Compute Summit

January 28–29, 2014 San Jose

Open Rack Workshop

Open Rack Standard Update

Front Post

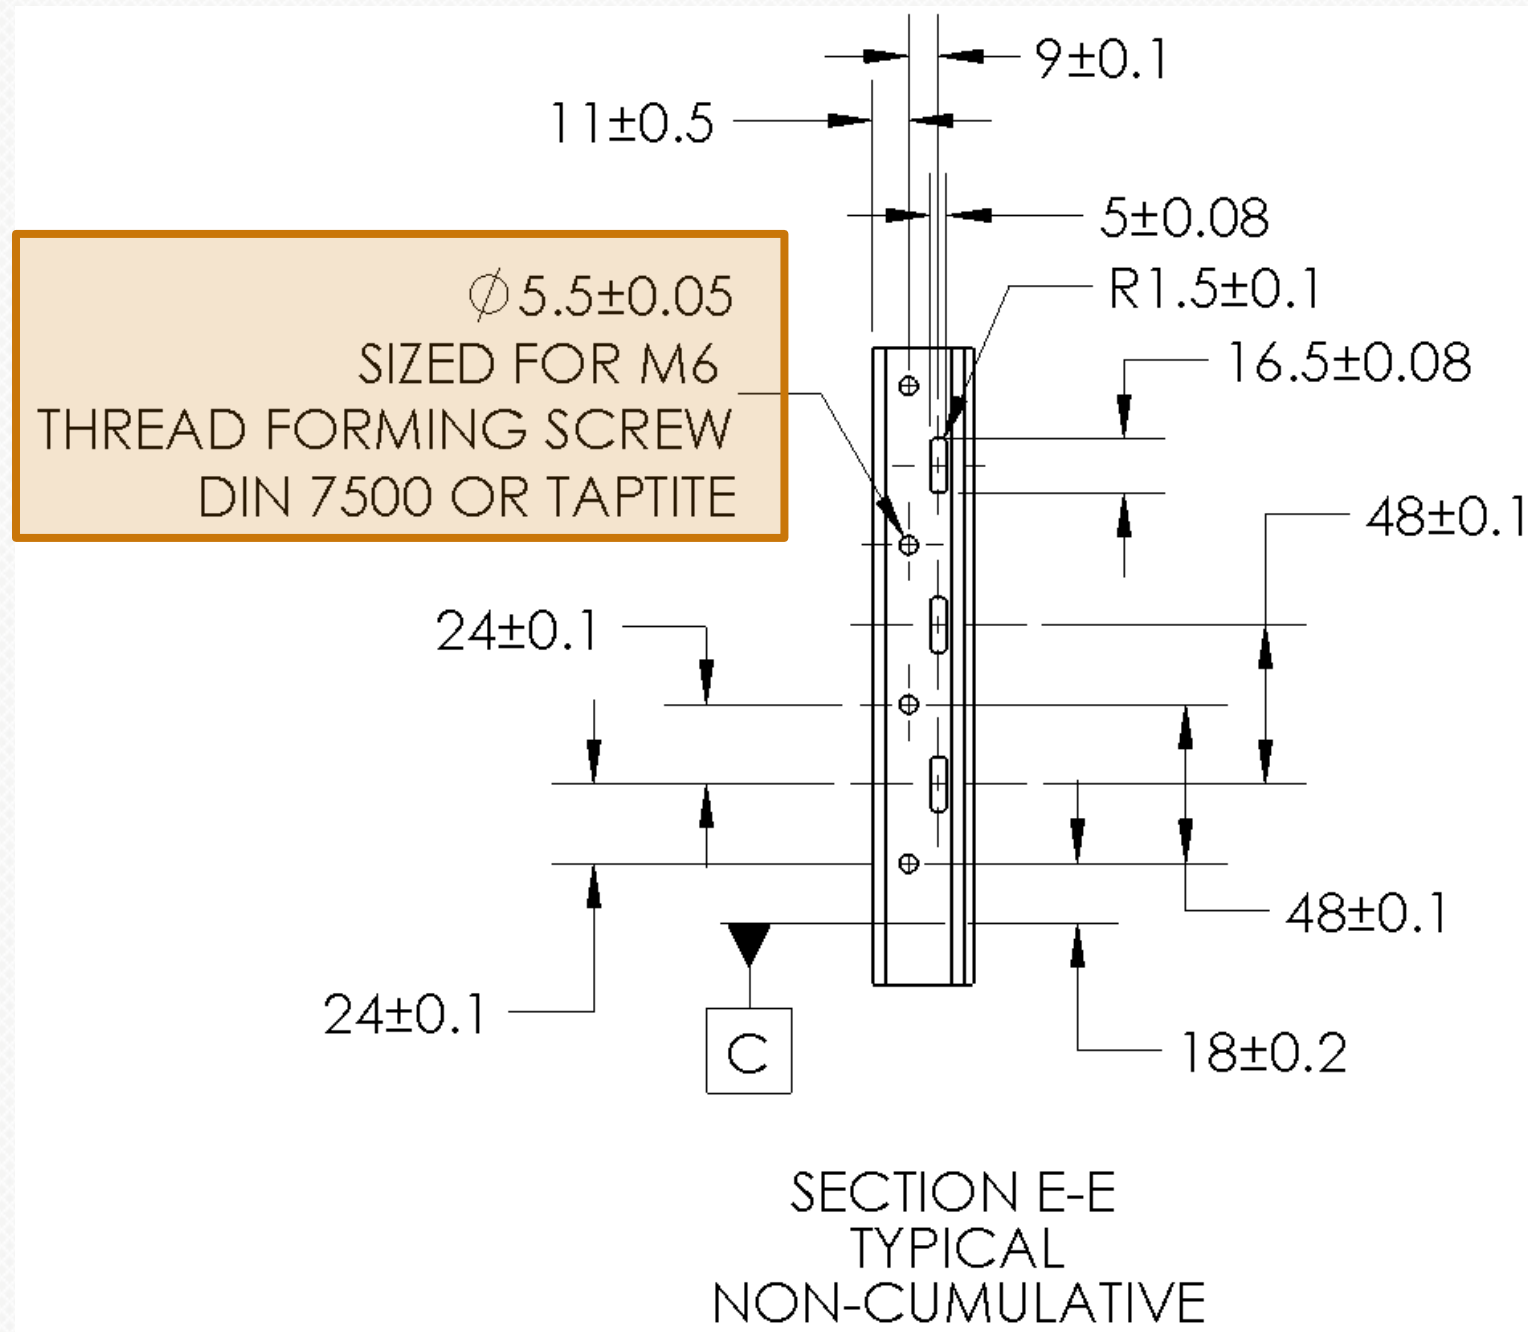
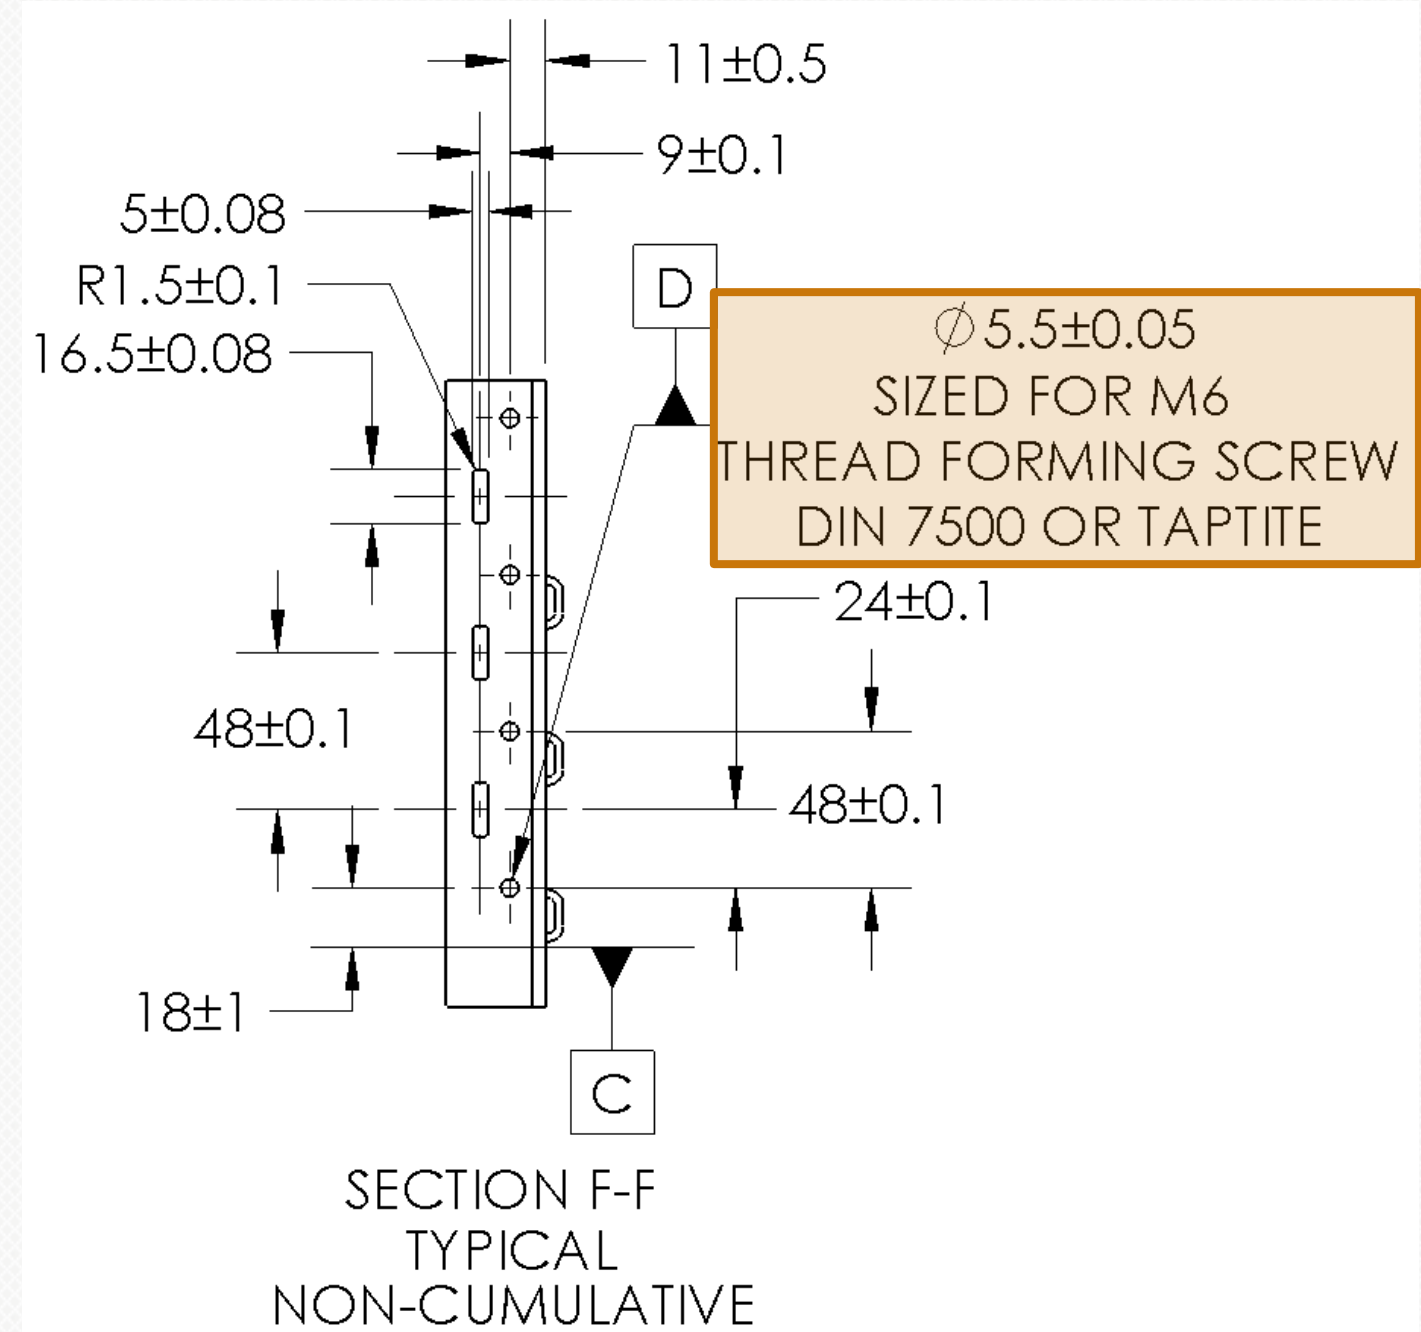
Standard: Change hole diameter from 5.42 to 5.5

SECTION B-B
IT GEAR SUPPORT BRACKETS REMOVED

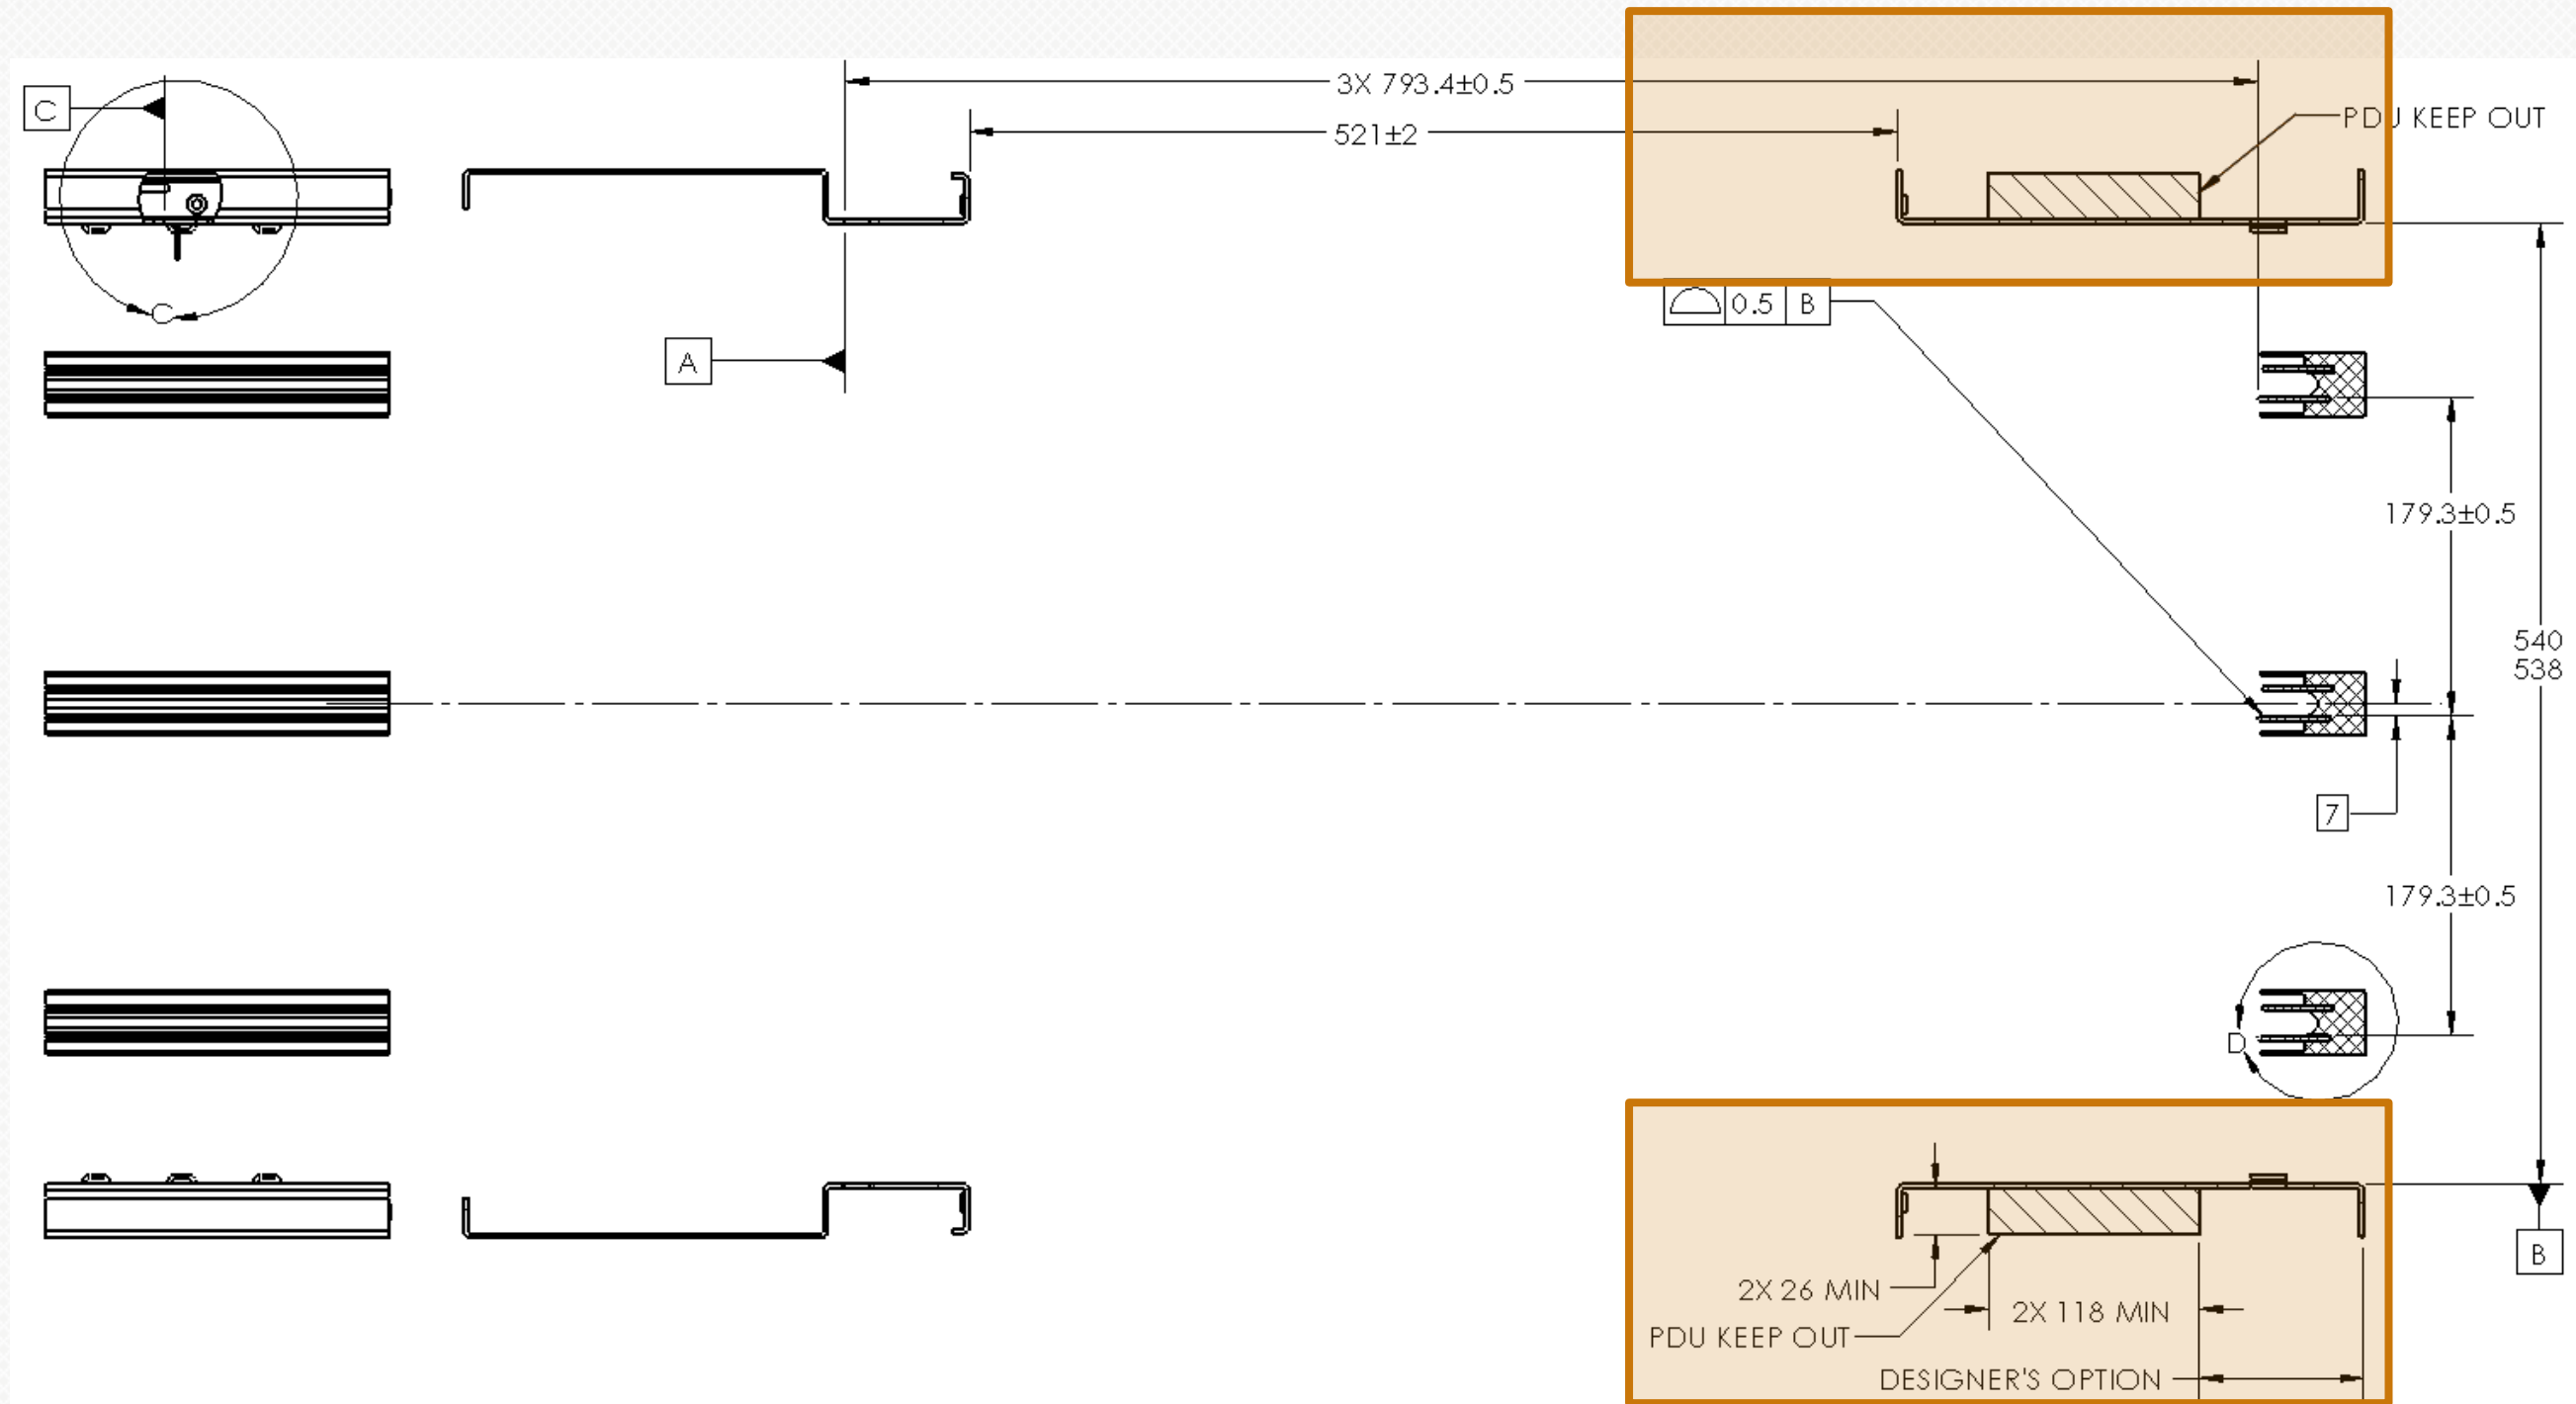
Standard: Reserve PDU Volume

Standard: IT Support Brackets

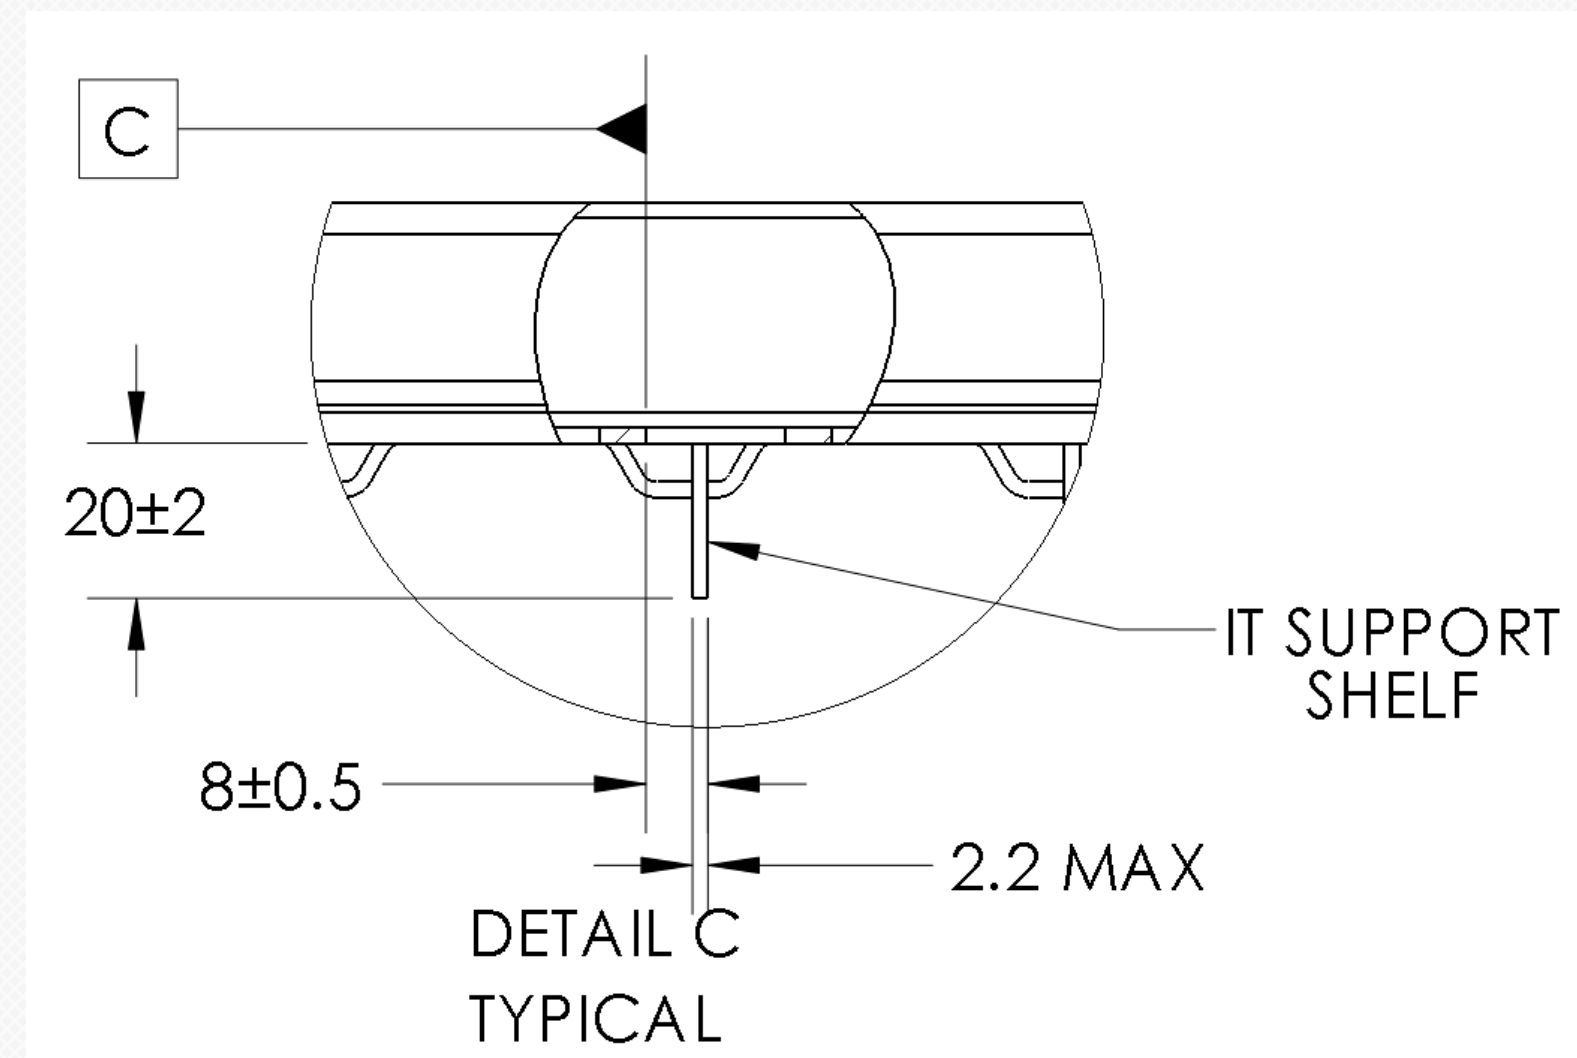
- Conform to the shape shown in Detail C (Figure 7). If the IT Support Bracket is continuous along the entire width of the rack instead of two Support Brackets, then the 20mm bracket length in Detail C may be ignored.
- IT load changed to 700N per set

Add connection for Power Shelf to Rack Busbar

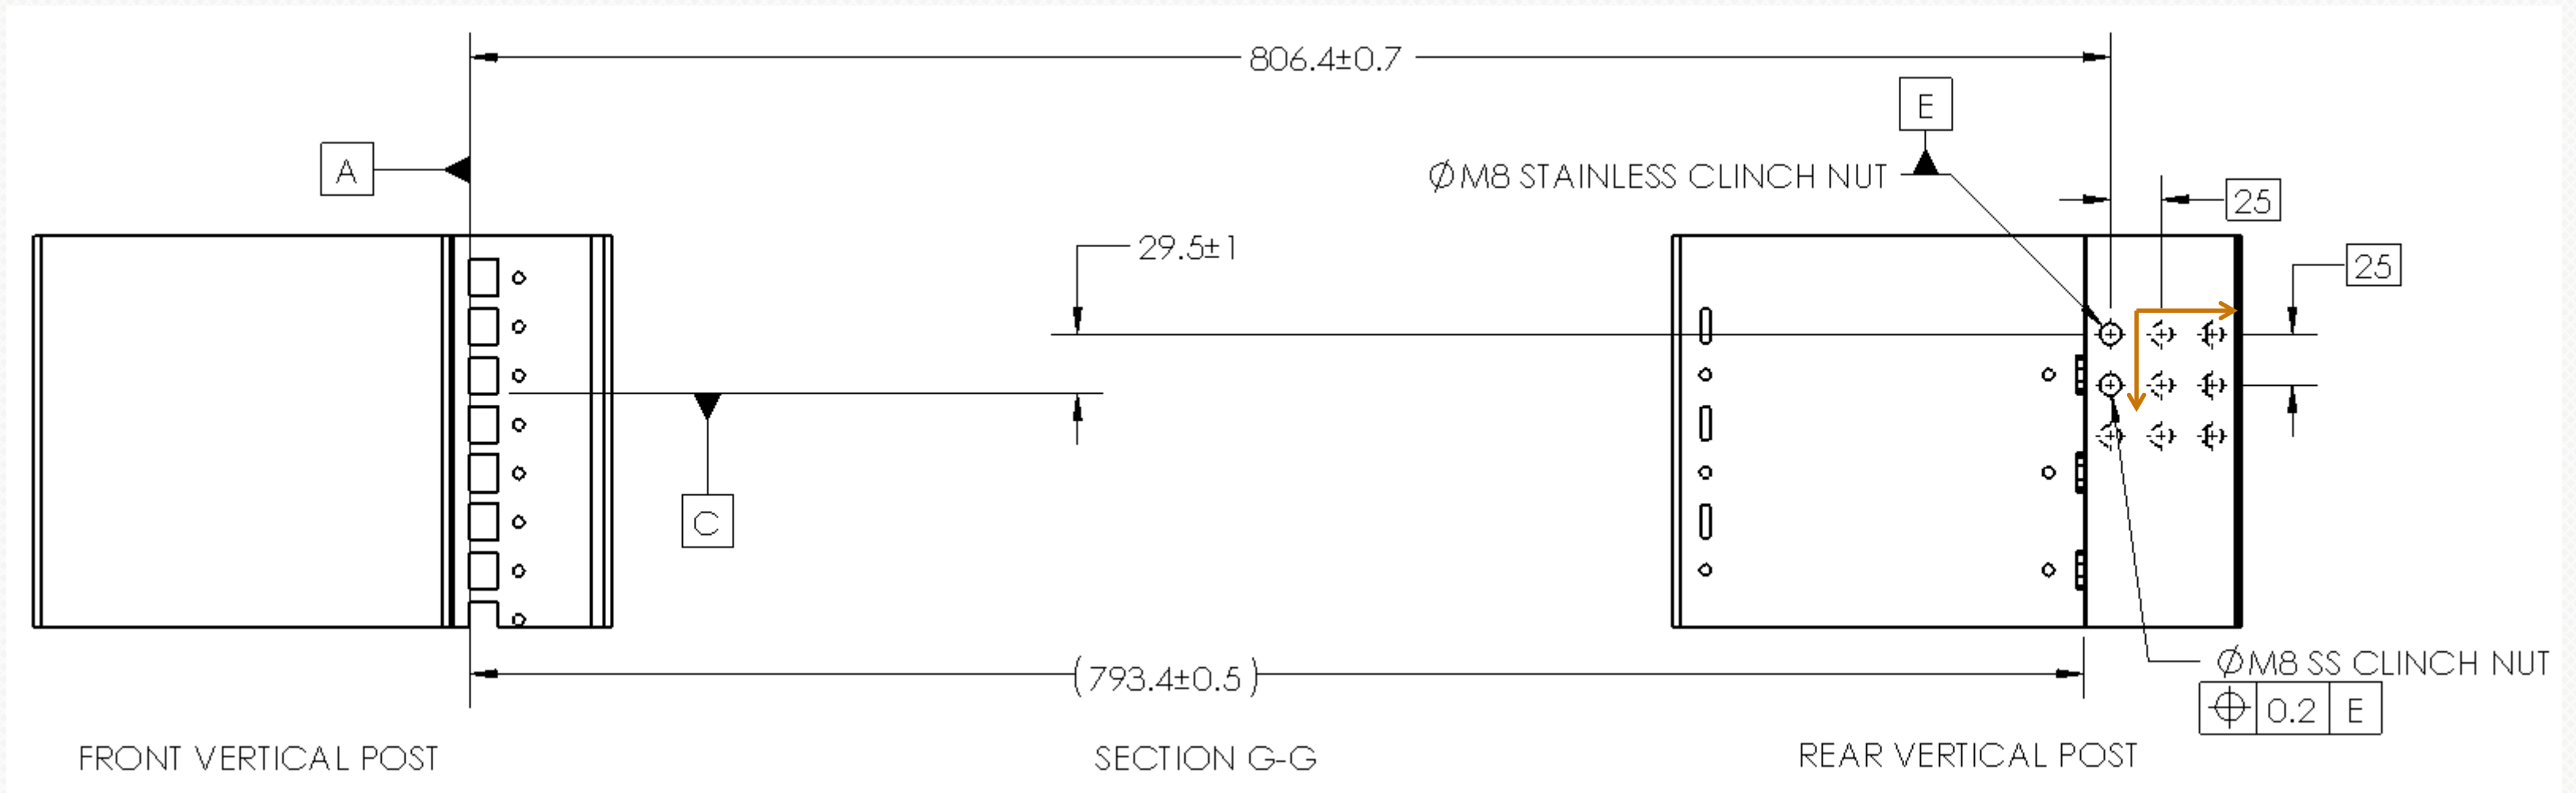
Start with Hole at Datum E and add holes to the busbar in a 25x25 array
